## **Proposal for amendments to Regulations Nos. 19, 48 and 98.**

### **Submitted by the expert from Germany**

### A1. Proposal for Supplement 02 to the 04 series of amendments to Regulation No. 19

## A2. Proposal for Supplement 08 to the 04 series of amendments to Regulation No. 48

### ANNEX 10

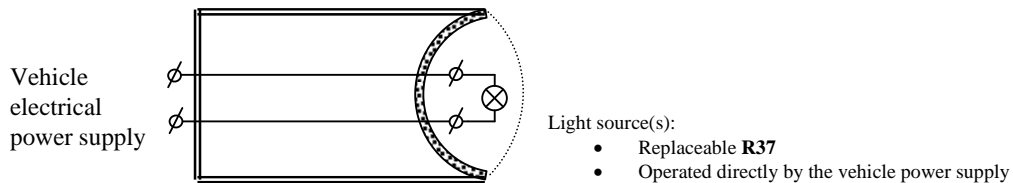
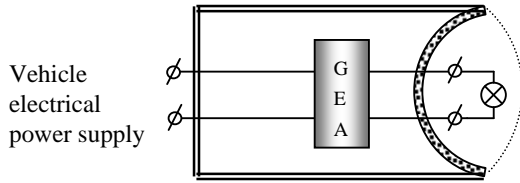
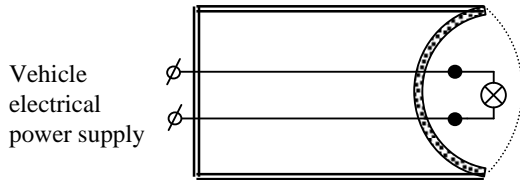
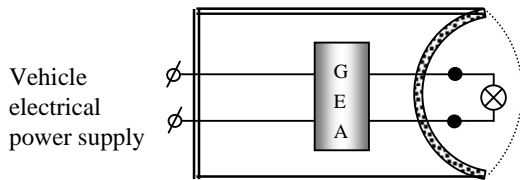
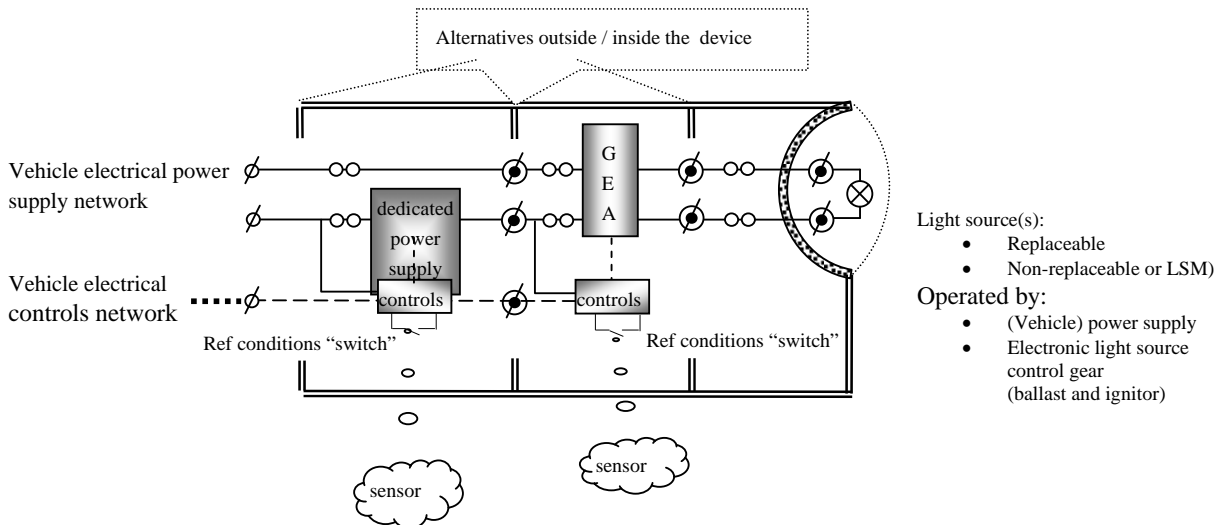
Annex 10, amend to read:
